Work Order ID 139378***139378***

Item ID: D212-725-1-223F

Item Name: Angle

DESIGN	RF	DART AEROSPACE LTD HAWKESBURY, ONTARIO, CANADA	
DRAWN	RF		
CHECKED	<i>[Signature]</i>	DRAWING NO. D4258	REV. B
MFG. APPR.	<i>[Signature]</i>	SHEET 10 OF 13	
APPROVED	<i>[Signature]</i>	TITLE	SCALE
DE APPR.	<i>[Signature]</i>	SHIELD TAIL PIPE ASSEMBLY	NTS
DATE	12.11.15	COPYRIGHT © 2011 BY DART AEROSPACE LTD THIS DOCUMENT IS PRIVATE AND CONFIDENTIAL, AND IS SUPPLIED ON THE EXPRESS CONDITION THAT IT IS NOT TO BE USED FOR ANY PURPOSE OR COPIED OR COMMUNICATED TO ANY OTHER PERSON WITHOUT WRITTEN PERMISSION FROM DART AEROSPACE LTD.

D212-725-1-223F FLAT PATTERN B

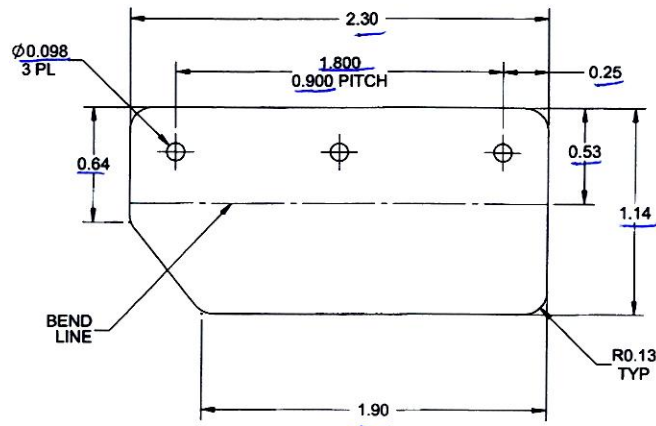
0.025 THK (24 GAUGE) USED				ACCEPTABLE, OPEN PAR TO CHANGE ON 0212-725-1-223F DRAWING, MTL SHOULD READ "0.025 THK (24 GAUGE)" <u>PAR 16-482</u>				Completed By <u>A.P.</u> 15.12.01	
								Lead hand / Supervisor Approval Verification <u>DAS</u> <u>9</u> <u>9-89</u> <u>15-12-18</u>	
								QC / QA Coordinator Approval <u>DAS</u> <u>9</u> <u>9-89</u> <u>15-12-18</u>	
Root Cause				FAULT CATEGORY					
Environment ☐	No Re-verification ☐	Pressure/Forced ☐	Temperature/Cure ☐	Power Loss/Surge ☐	Positioned Wrong ☐				
Design ☐	Operator ☐	Bending ☐	Set-up ☐	Folio/Program ☐	Outside Dimensions ☐				
Doc/Data ☒	Offset/Setup ☐	Centre Not Concentric ☐	BOM/Route ☒	Grain ☐	Over/Under tolerance ☐				
Equip/Tooling ☐	Supplier ☐	Cracks ☐	Broken/Damage/Defect ☐	Weld ☐	Part Incorrect ☐				
Handling/Pre ☐	Training ☐	Crimp/Kink/Ripple/Wave ☐	Inspection Incomplete/Unqualified ☐	Wrong Stock Pulled ☐	Part Lost/Missing ☐
